**Addendum No. 1
December 8, 2021**

Project: Corsica-Stickney Elementary School Addition
Stickney, South Dakota
Architect's Project No.: 2910
Architect: Architecture Incorporated
Opening: December 16, 2021
2:00 pm CST
Elementary School Gymnasium

1 ENLARGED PLAN
4.41 SCALE: 1/4" = 1'-0"

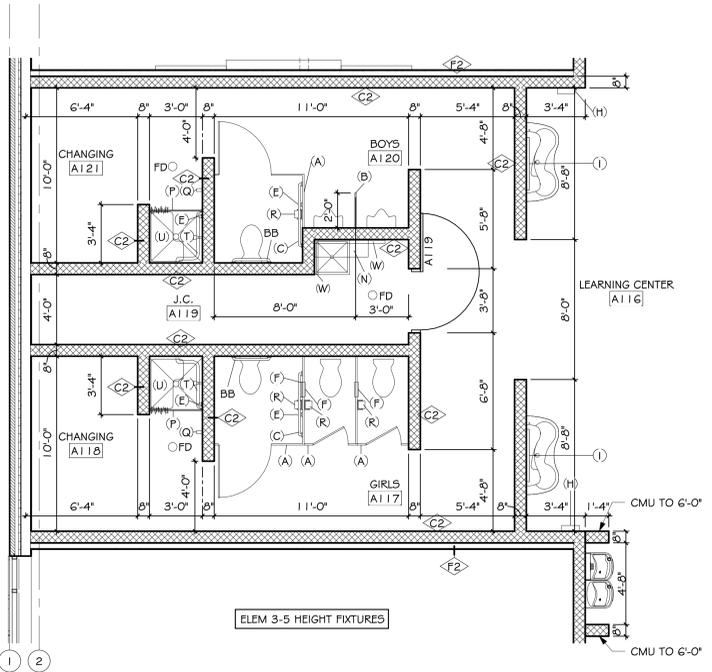
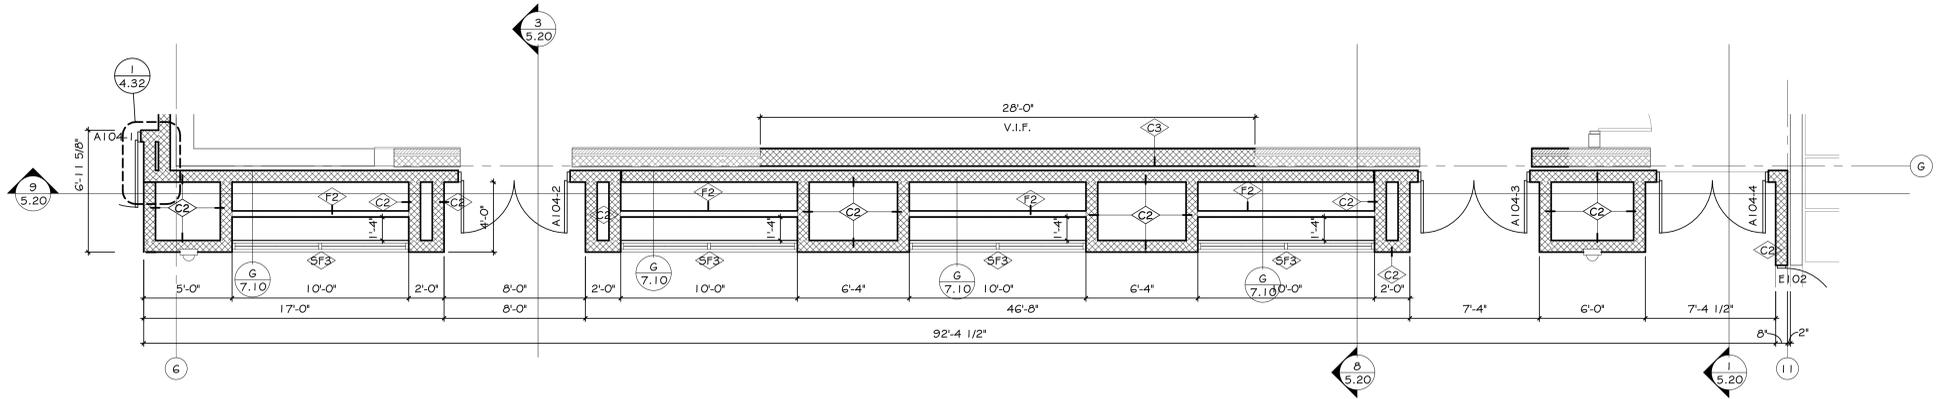
- 4) SHEET 4.41 ENLARGED FLOOR PLANS: See new sheet with changes clouded and tagged with “1”
 - a) **DETAIL 1: ADD** 18” x 36” mirrors type ‘j’ above lavatories in rooms A105 and A107 as indicated.

CORSICA-STICKNEY ELEM. SCHOOL ADDITION
WINDOWS AND STOREFRONTS

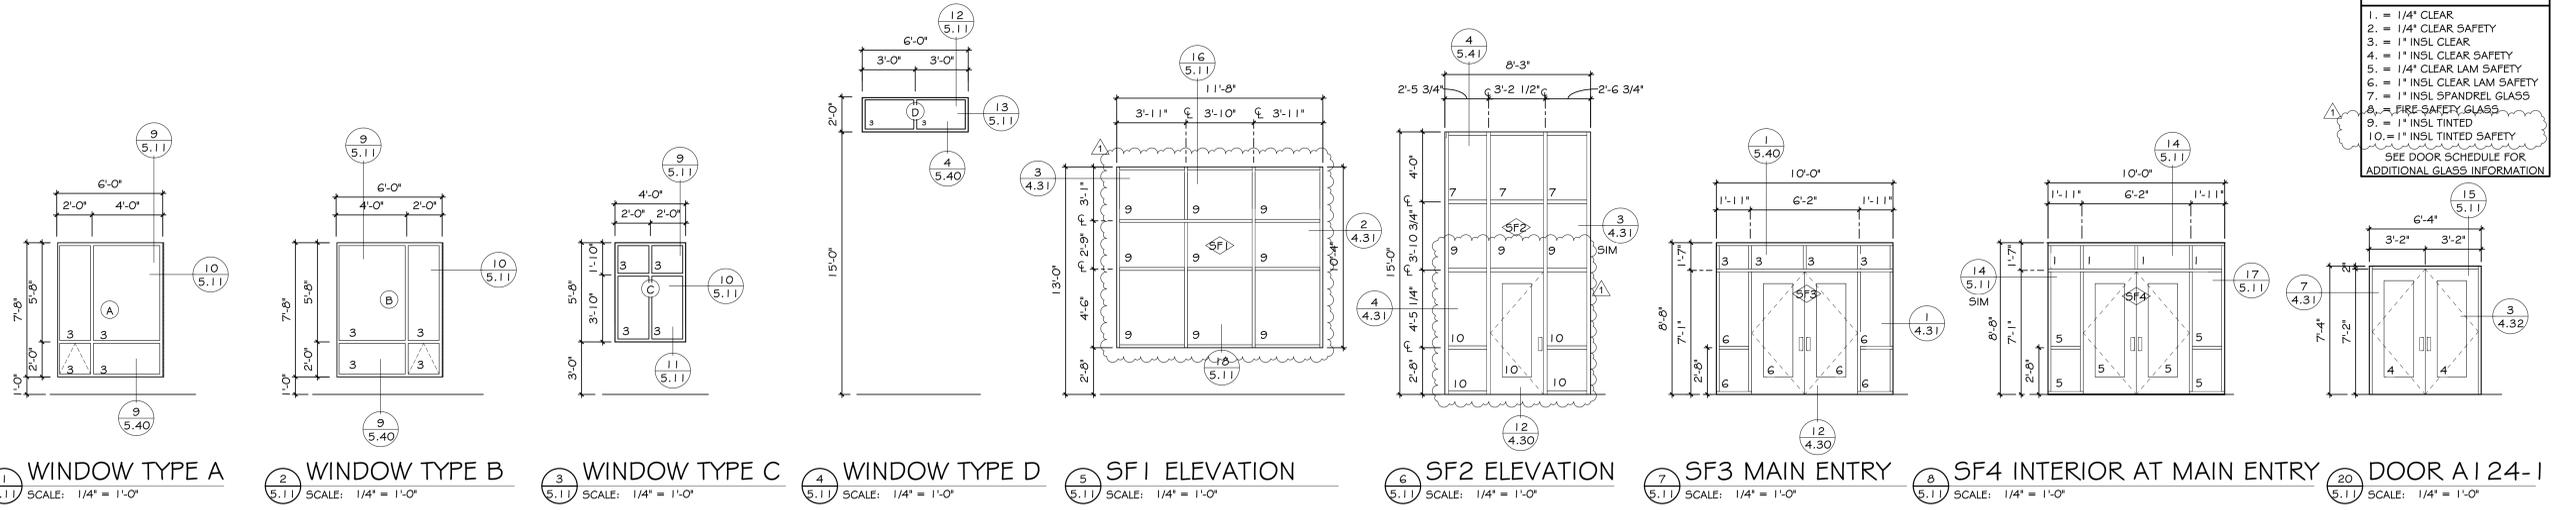
- 5) SHEET 5.11 WINDOWS AND STOREFRONTS: See new sheet with changes clouded and tagged with “1”
 - a) **ADD** Tinted Glass type to Window Type Schedule
 - b) **MODIFY** glass types on Storefront elevations as indicated

DRAWING SHEET 9.30 – FIRST FLOOR PLAN – LIGHTING

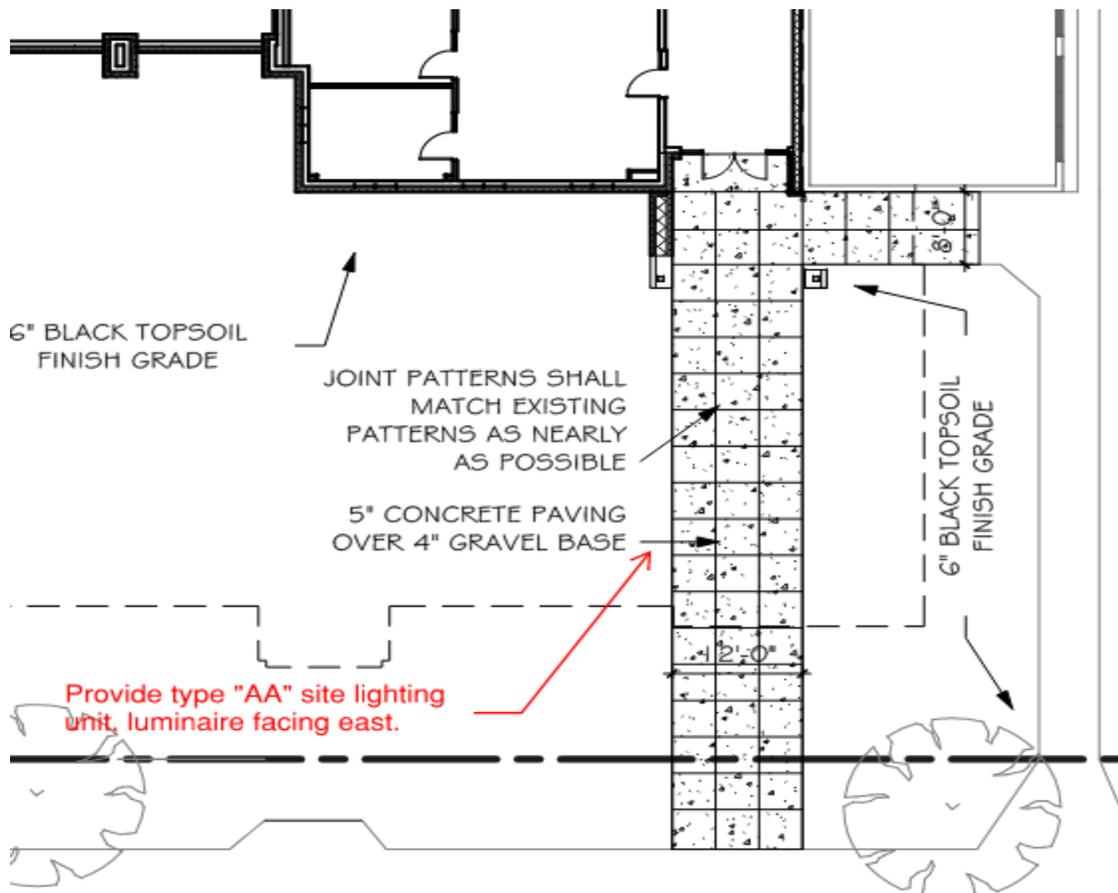
1. Exterior: Provide a type “AA” site lighting at the south entry at the location shown below. Connect to the type “Y” building mounted luminaire to the north.

SHORT POLE BASE DETAIL

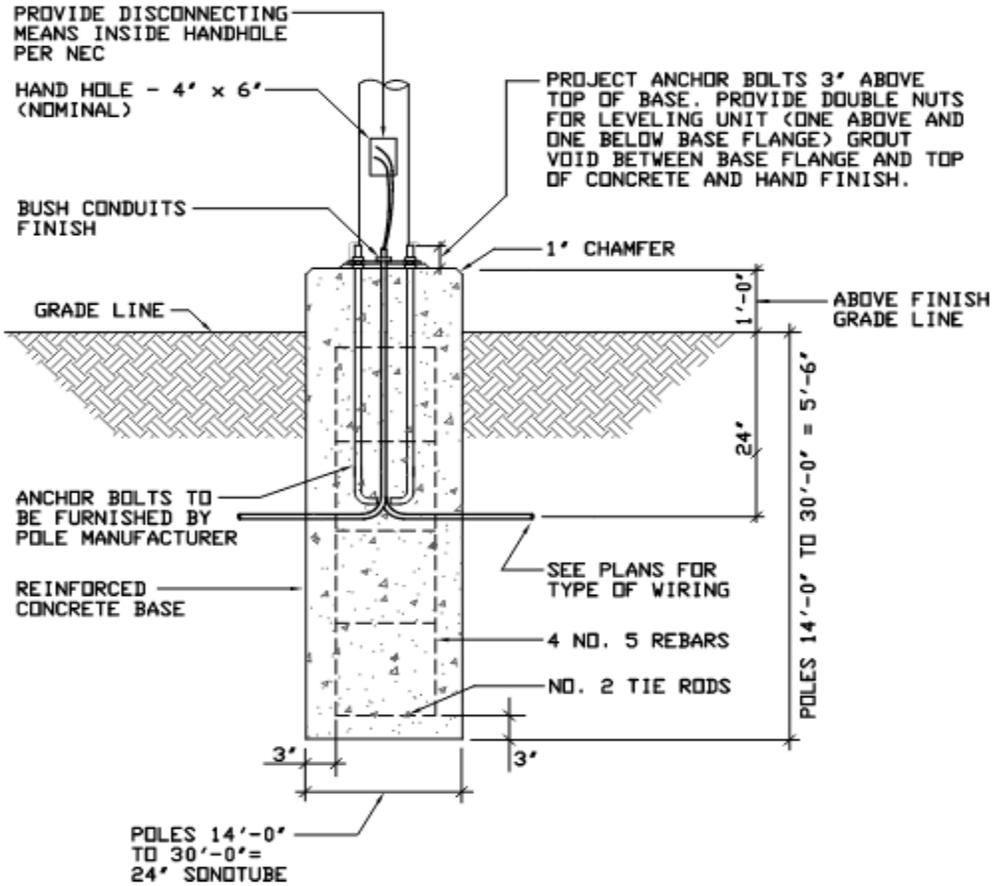
1. Add the pole base detail shown below.
